JAX KAR WASH

FORMAL PRO PLAN

PLAN REVIEW CENTER REPORT

Rezoning Request from RC Regional Center to B-3 General Business with a Planned Rezoning Overlay

PRELIMINARY OVERALL FLOOR PLAN
SCALE: 1/8" = 1'-0"

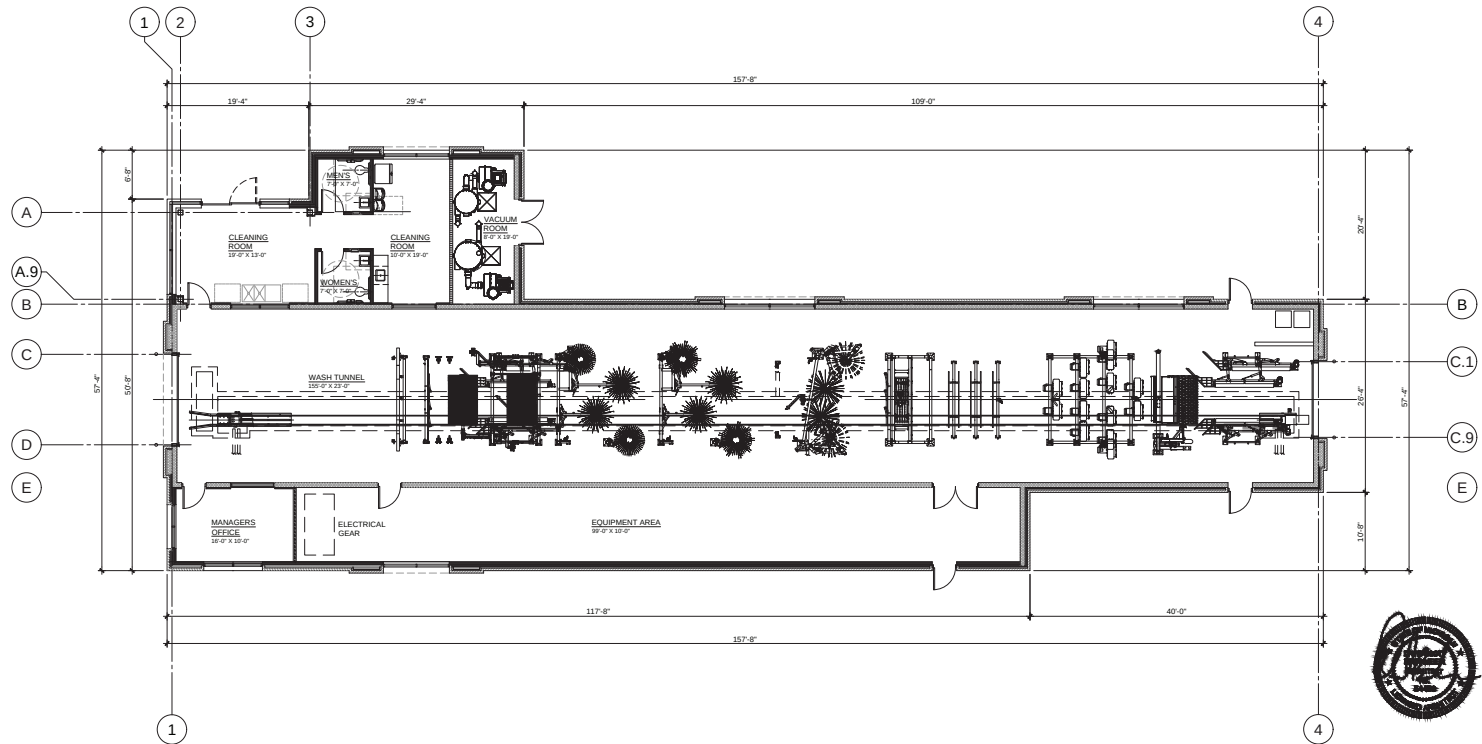
- The proposed vacuum system is located within the proposed building, see sheet PFP-1 Floor Plan for details. It's denoted as "Vacuum Room".
